MOONEY AIRCRAFT INC.  
KERRVILLE, TEXAS  
SERVICE LETTER 20-19

DATE: 12-18-56  
SUBJECT: Kit-Cabin Door Latch

MODELS AFFECTED: ~~M 20 Serial Numbers 1062 Thru 1116~~

Figure 1.

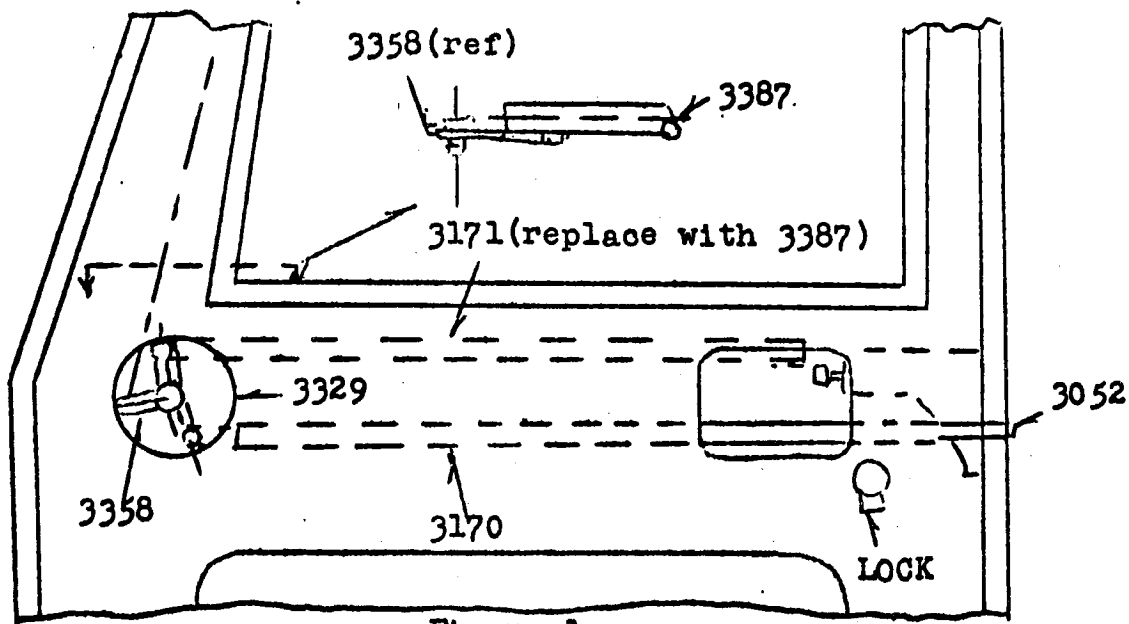
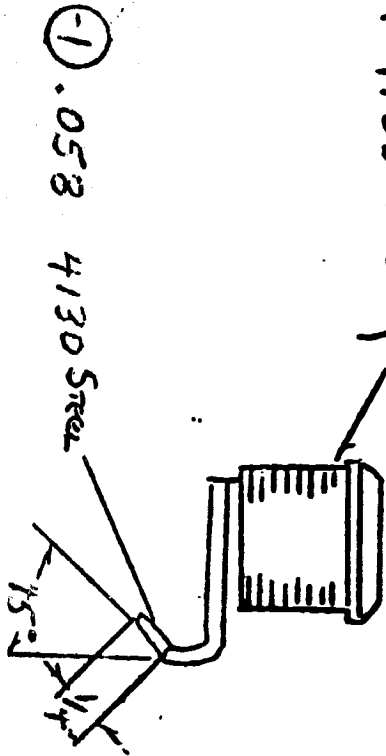
Difficulty has been experienced in the operation of the cabin door latch mechanism due to the following causes.

1. With the cabin door locked, enough force can be applied to the outside handle to force P/N 3170 past the lock, when the door is closed, if P/N 3170 hangs on the lock going back, P/N 3171 will be bent.
2. P/N 3171 Can also be bent if P/N 3052 is not in line with its hole in the striker plate when the door is closed. If P/N 3171 is bent, the latch mechanism will not function properly. To eliminate these problems, compliance to the following instructions is recommended.

1. Remove window frame and inside handle from door. Hold lower upholstery panel out of the way.
2. Remove P/N 3329 being careful to retain washer spacers which are between this plate and P/N 3358.
3. Remove P/N 3171 and replace with new part P/N 3387 as shown.
4. Remove lock and weld on small tab as shown on drawing #3386.  
CAUTION: Wrap body of lock in a wet rag and keep rag wet during welding operation.
